Access Compliance Report

Public Rights-of-Way

(Curb Ramps)

Intersection ID: 27211	Main Street: FORBES_DR	Cross Street: PROVIDENCE_RD	Location: NW
ADA ID: 145556051A96	Ramp Type: PerpDiag	Initial Pass/Fail: Fail	Overall Compliance: No
		Severity Score: 10

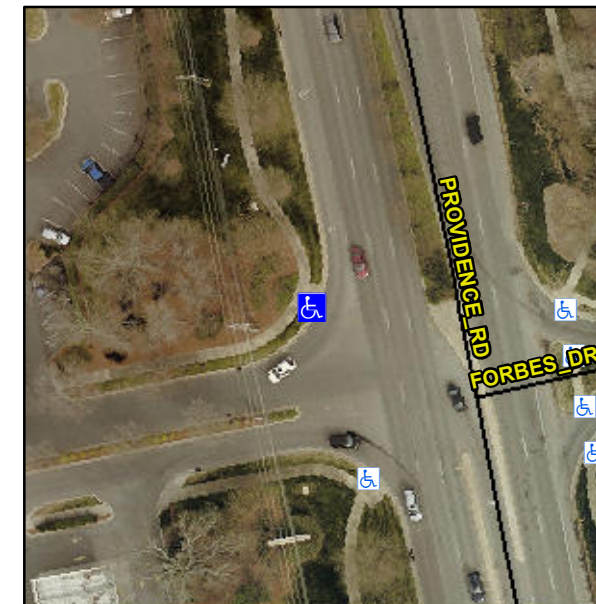
R304.5.1, R304.5.3

Compliance	Description	Data	Compliance	Description	Data
N/A	Ramp Length (in)	72.0	Yes	Ramp Slope (%)	5.1
No	Ramp Width (in)	46.0	No	Ramp XSlope (%)	4.1
N/A	Flare Type LT	N/A	N/A	Flare Type RT	N/A
N/A	Flare Slope LT (%)	N/A	N/A	Flare Slope RT (%)	N/A
N/A	Flare Traversable LT?	N/A	N/A	Flare Traversable RT?	N/A
N/A	Landing Length (in)	N/A	N/A	DWS Provided?	N/A
N/A	Landing Width (in)	N/A	N/A	DWS Contrast?	N/A
N/A	Landing Slope (%)	N/A	N/A	DWS Length (in)	N/A
N/A	Landing X Slope (%)	N/A	N/A	DWS Full Width?	N/A
N/A	Landing Curb? (Y/N)	N/A	N/A	DWS Offset (in)	N/A
N/A	Shared Landing?	N/A			
N/A	Gutter Ponding?	N/A	N/A	Gutter Slope (%)	N/A
N/A	Gutter Lip Ht (in)	N/A	N/A	Gutter X Slope (%)	N/A
N/A	Painted X Walk1?	No	N/A	Painted X Walk2?	No
	X Walk 1 Direction	To S		X Walk 2 Direction	To E
N/A	X Walk 1 Width (in)	N/A	N/A	X Walk 2 Width (in)	N/A
	X Walk 1 Slope (%)	0.3		X Walk 2 Slope (%)	0.5
	X Walk 1 X Slope (%)	4.5		X Walk 2 X Slope (%)	1.1

Remove & Replace Curb Ramp With Two New Directional Ramps or Equivalent.
